ALBUQUERQUE INTERNATIONAL
AIRPORT
LANDSCAPE DEVELOPMENT
A.D.A.P PROJECT #6-35-0003-10

ACCESS ROAD 'A'

RECORD DRAWING

STAKING PLAN 1" = 50'

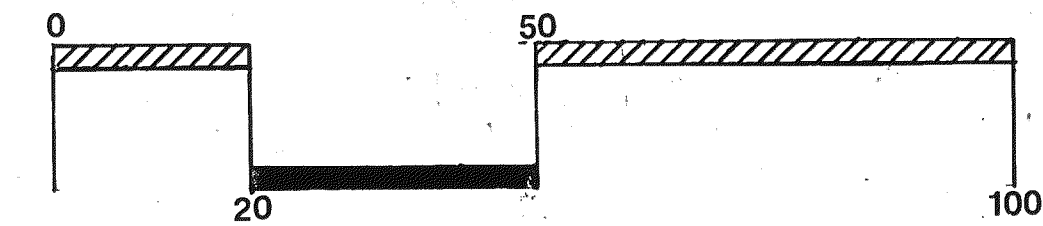
AS-BUILT NOTE:
 ACTUAL CONSTRUCTED LOCATION OF PATH WAS ADJUSTED IN FIELD AND VARIED SLIGHTLY FROM LOCATION INDICATED ON THIS SHEET.

* SEE AS-BUILT NOTE UPPER LEFT THIS SHEET

1 RETAINING WALL GRADING
10

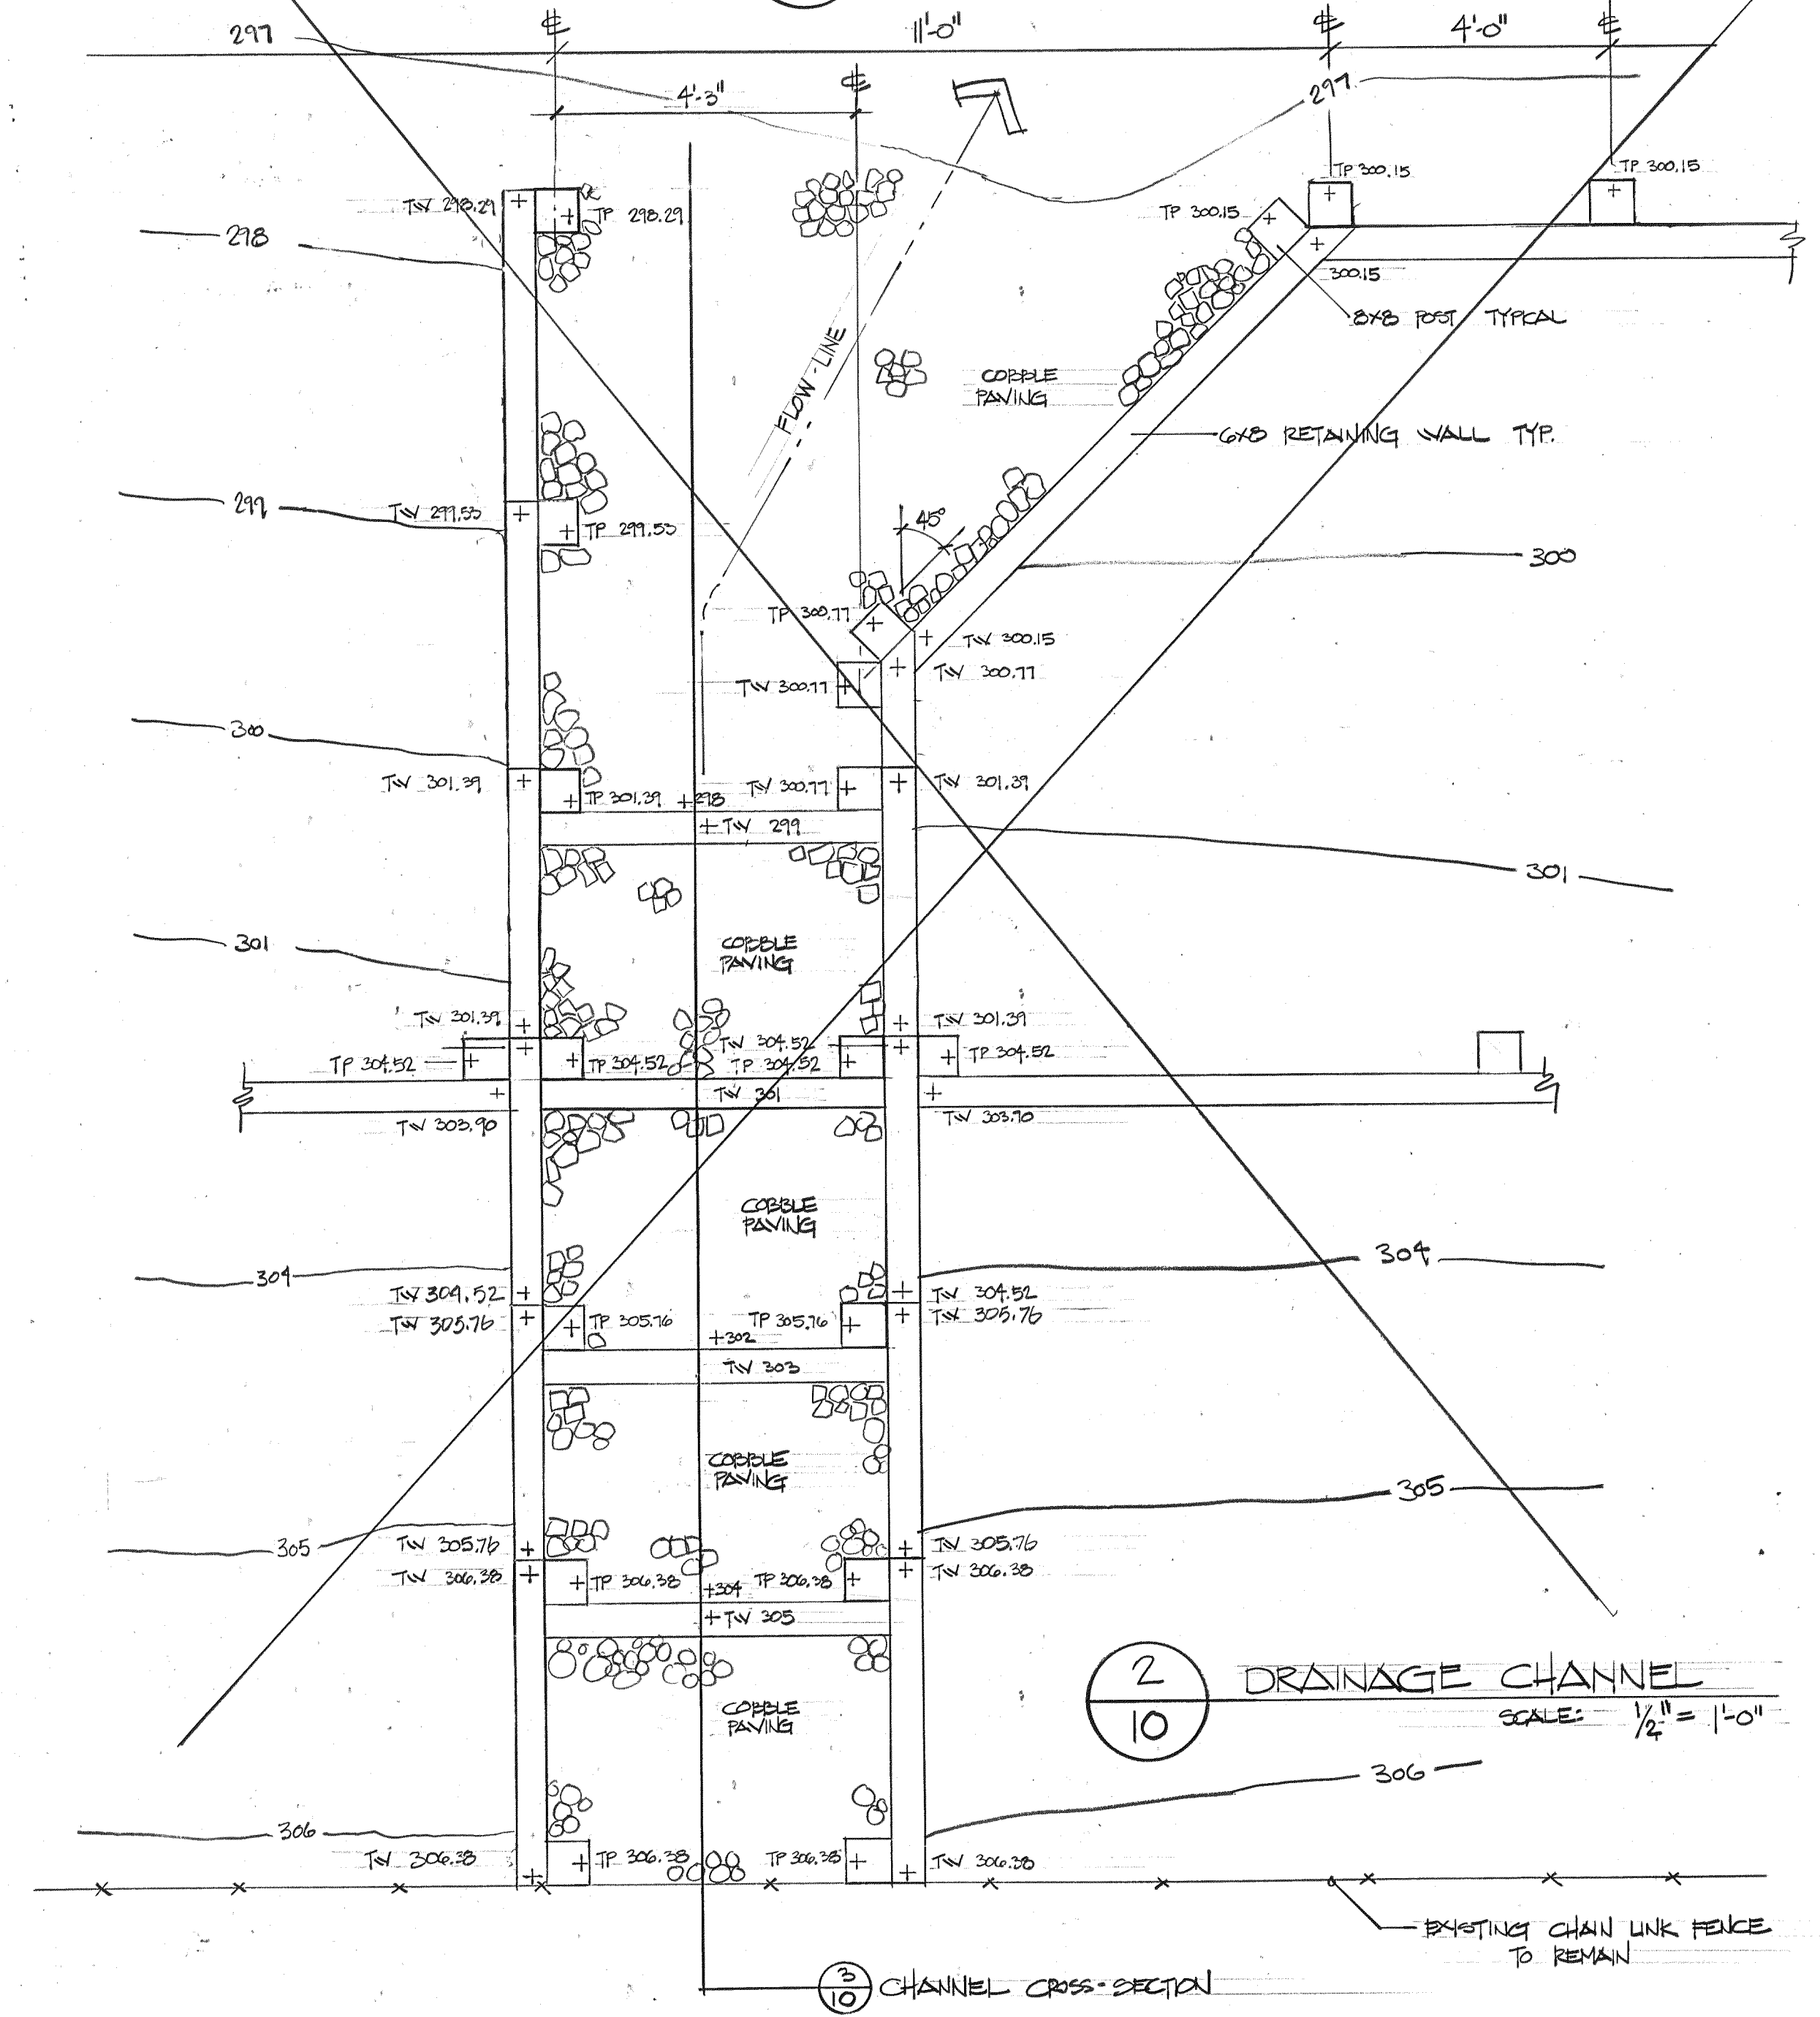
AS BUILT NOTE:
SEE SHEET #8 OF 11 FOR ACTUAL
LOCATION OF RETAINING WALLS, DRAINAGE
CHANNEL AS INDICATED IN DETAILS
2/10 3/10 NOT INSTALLED.

2 TYPICAL POP-UP SPRINKLER INSTALLATION
N.T.S.

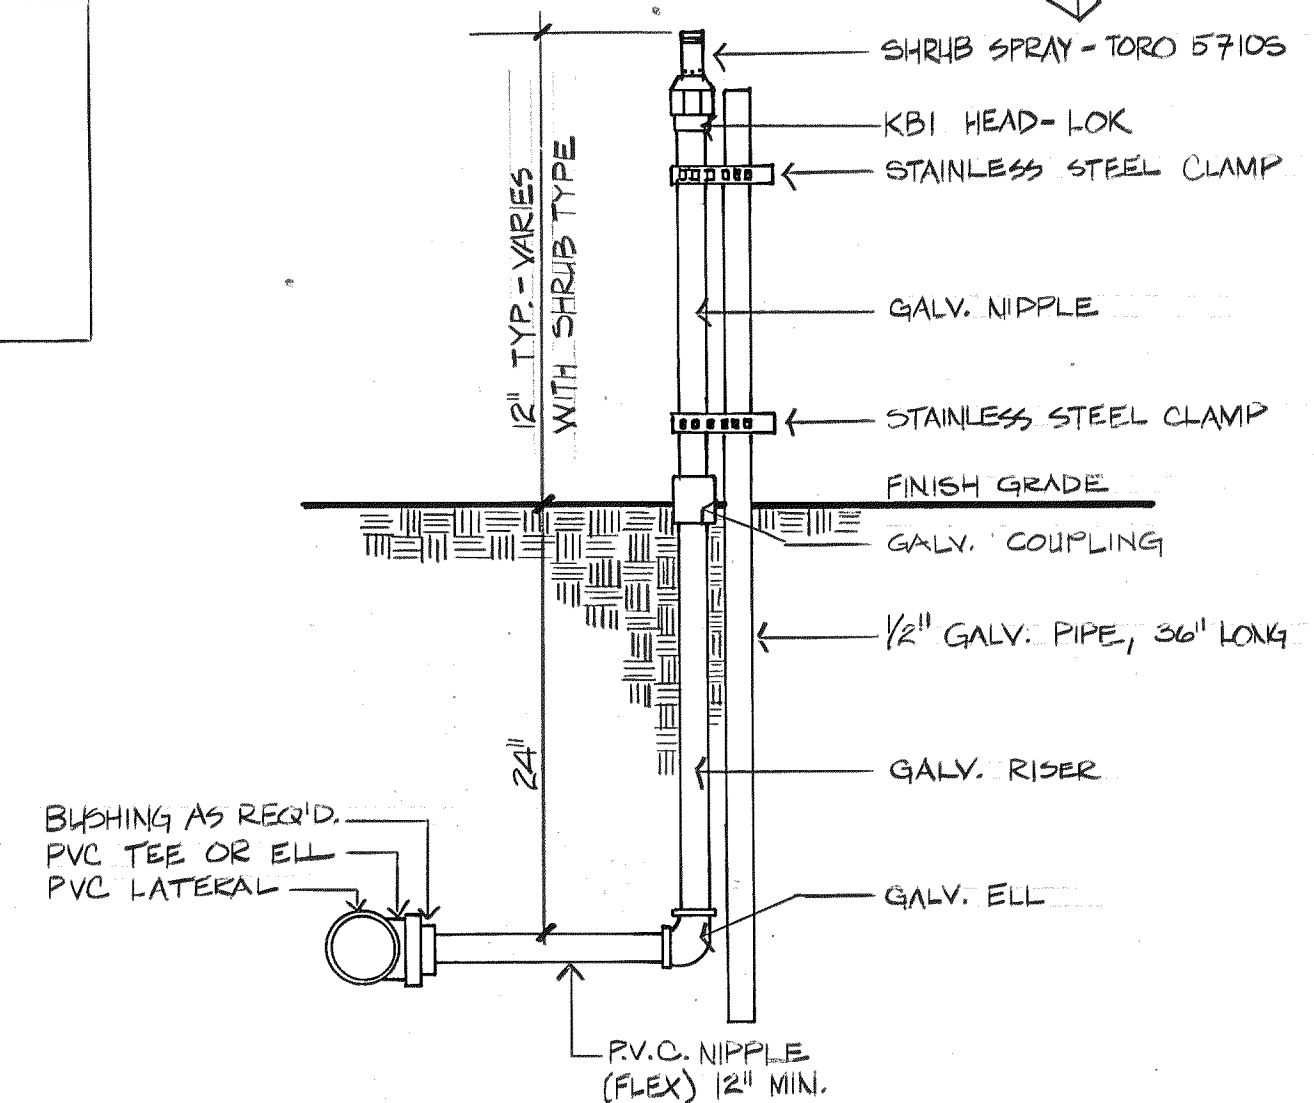
AS BUILT NOTE:
WEATHERMATIC G-40P & G-40F
APPROVED AS SUBSTITUTE
AND INSTALLED

6 ROTARY IMPACT POP-UP
N.T.S.

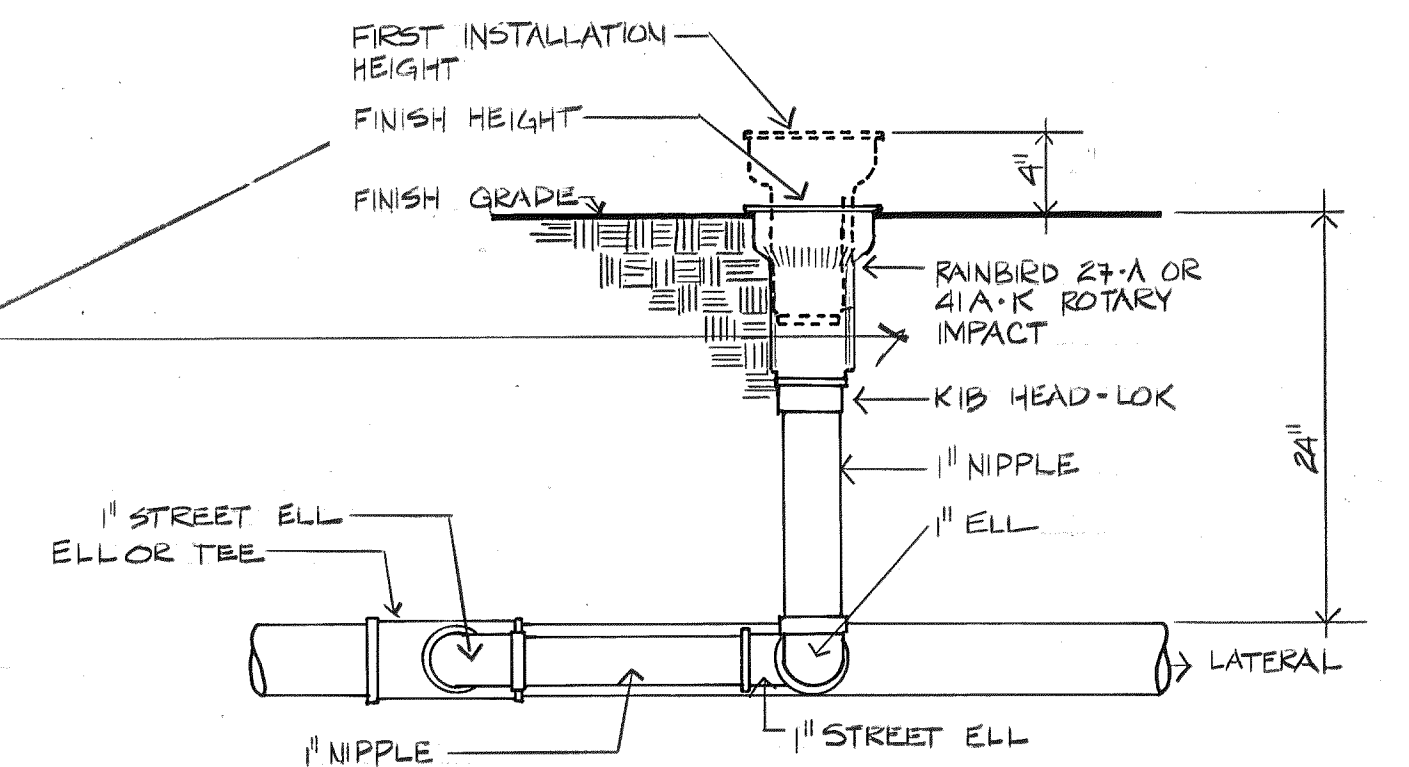
AS BUILT NOTE:
WEATHERMATIC K-50P X V-58,
K-70F X V-58 APPROVED AS
SUBSTITUTES AND INSTALLED
